RAYMOND SERVICE INFORMATION

RSI CTB-18-007
November 28, 2018

SUBJECT: Carriage Stop Replacement

Figure 1

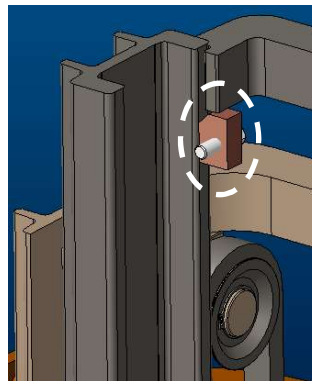
SERVICE INFORMATION: If existing carriage stop bolt is bent or broken, replace it with new carriage stop plate P/N 1270906 per the following procedure:

1. Raise the mast slightly to gain access to the upper portion of the inner telescopic.
2. Block the mast. Turn the key switch OFF and disconnect the battery connector.
3. Take measures to protect mast components from grinding and welding operations.
4. Remove damaged stop bolt and existing "welded on" block. See **Figure 1**.

NOTE: Do NOT use a cutting torch – grind off only.

Figure 1

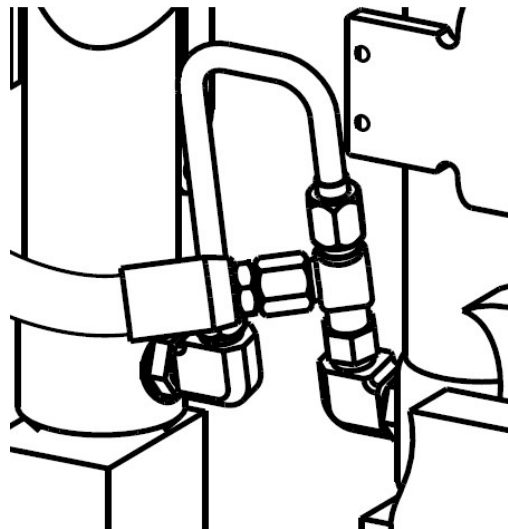
GENERAL INFORMATION: The trucks referenced above may stage incorrectly when lifting in temperatures below 70°F when using standard oil (P/N 990-616). A larger sized crossover tube and fittings is available. The most likely OACH's where this may occur are 83 to 88 inches, however, the new hardware can be installed on all TT mast OACH's.

SERVICE INFORMATION: Replace crossover tube P/N 1216820/001 with P/N 1297428/001 along with the associated hose and fittings (see Figure 1 and Table 1). The required hose is based on OACH (see Table 2).

Qty.	Description	P/N
1	Tee Fitting	790-808
2	90° Elbow	792-511
1	Crossover Tube	1297428/001
1	Hose	See Table 2

Figure 1

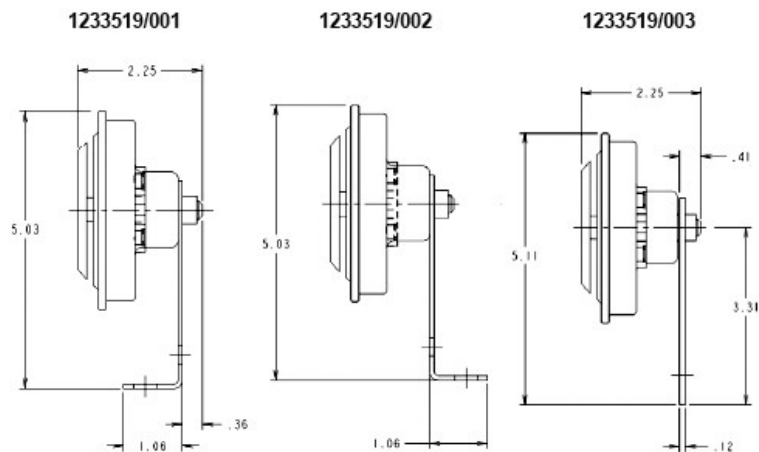
GENERAL INFORMATION: A new horn (P/N 1233519/XXX), designed to perform better in cold storage environments, is available to replace horn P/N 1047433/XXX.

SERVICE INFORMATION: Order and install P/N 1233519/XXX. Refer to Figure 1 for correct bracket configuration.

Connect Horn(+) and Horn(-) wires to the new horn. Make sure the horn bracket is isolated from the truck frame.

Figure 1

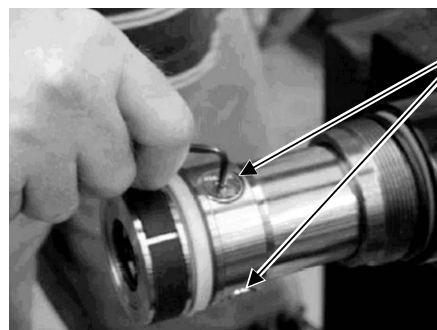
1. Remove the right-hand main cylinder and remove the piston from the cylinder.
2. Remove check valve. See Figure 1.

3. Inspect check valve. If the O-ring is blown off or appears damaged, replace the check valve (P/N 223-001-569/L14).
4. Clean check valve and apply thread-locking compound P/N 990-403 to thread circumference of check valve.

Figure 2

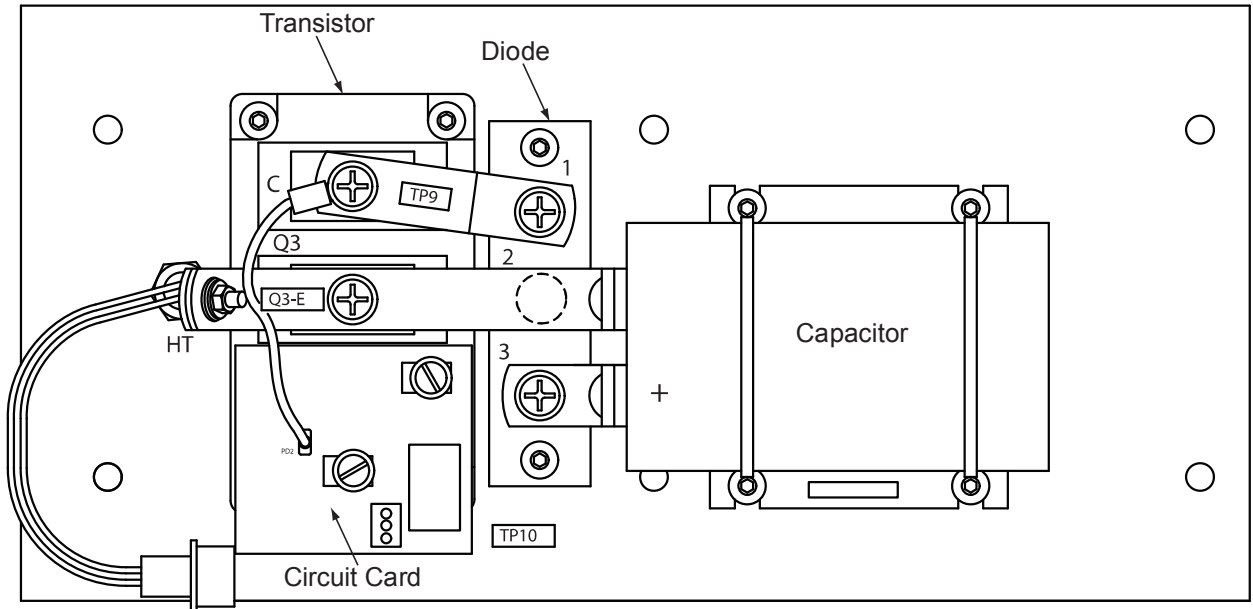
Electrical check of diode 1016321/001: (See Figure 2.)

1. Disconnect and remove the TP9 bus bar in order to electrically isolate the diode from Q3 collector (C).
2. Disconnect and remove the bus bar from capacitor to diode.
3. Measure the resistance from diode connection 1 (+ lead) to 3 (-lead). It should now read continuity.
4. Measure the resistance from diode connection 3 (+ lead) to 1 (-lead). It should now read open circuit.

Figure 2

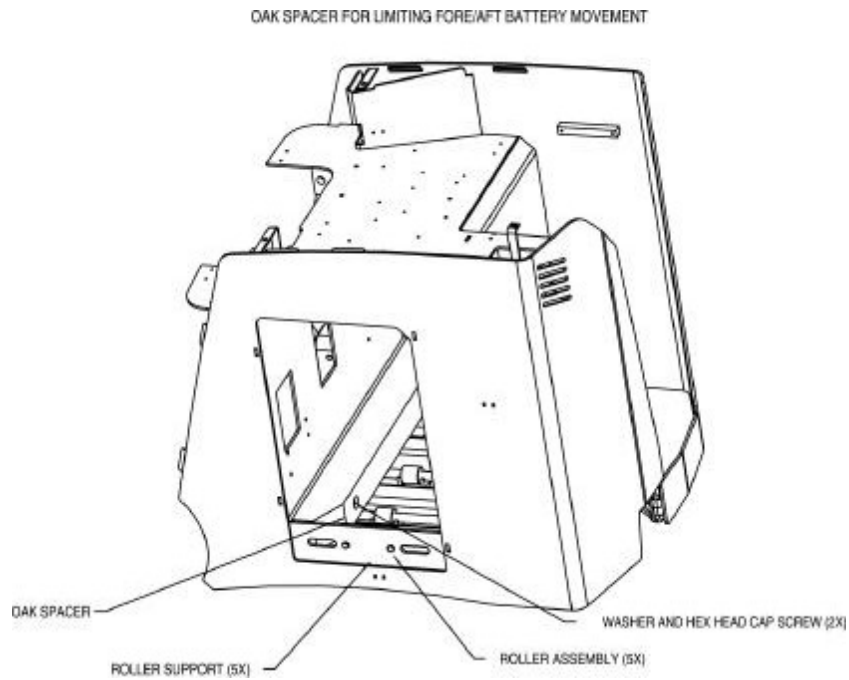
Install the required parts per Figure 2

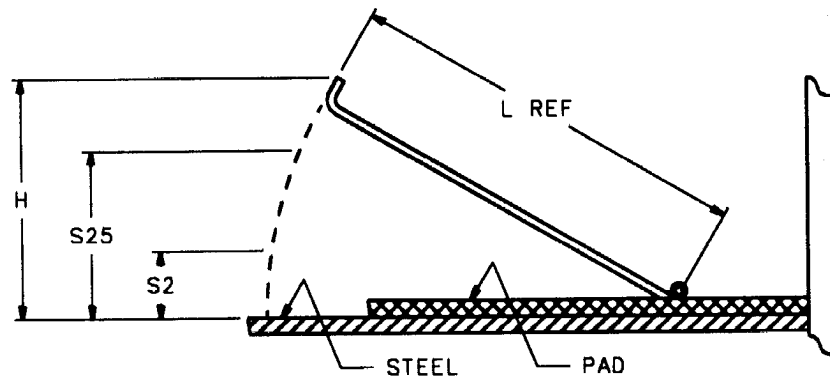
All measurements should be taken on the top lip of the deadman pedal from the steel floor of the operator's compartment. (See sketch below)

Adjust the length of the pedal rod so that the pedal height (H) and switch activations for S2 and S25 fall within the ranges specified below. In addition there should be a minimum of .5 inch travel left in the pedal when S25 deactivates.

L = 9.25	L = 13.87
H	4 - 4 1/4	5 3/4 - 6 1/4
S25	3 1/4 - 3 3/4	4 7/8 - 5 3/8
S2	1 1/4 - 2	2 - 3
